# Evaluation of DOE Supplemental Proposed Rulemaking on Residential Furnace Standards Life Cycle Cost Analysis: Inputs and Results with Emphasis on Southern California

RESEARCH REPORT PREPARED BY NEGAWATT CONSULTING FOR  
SUE KRISTJANSSON, SOUTHERN CALIFORNIA GAS

Figure 1: Commented distribution of residential gas furnaces by efficiency

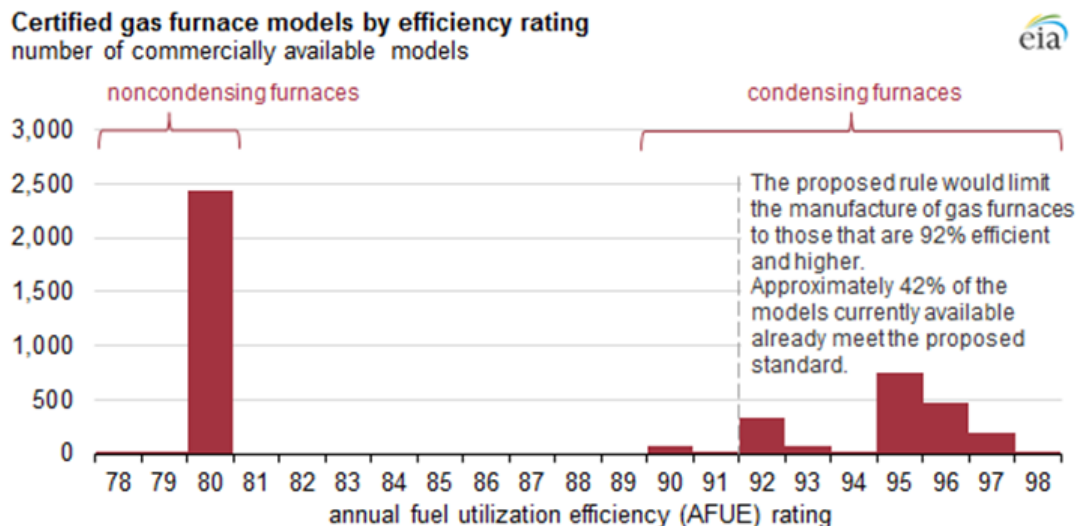
**One.** The national market appears to have moved substantially toward the proposed 92% AFUE level without it being mandated by a standard. The chart below shows that more than 50% of gas furnaces on the national market are already above 90% AFUE, 42% of which are above 92% AFUE (U.S. Energy Information Administration, Proposed efficiency standards may eliminate noncondensing gas furnaces, 2015).

These data can support the position that the standard is not needed, because where the higher efficiencies make economic sense, they are already being adopted by consumers. Government intervention would therefore appear unnecessary.
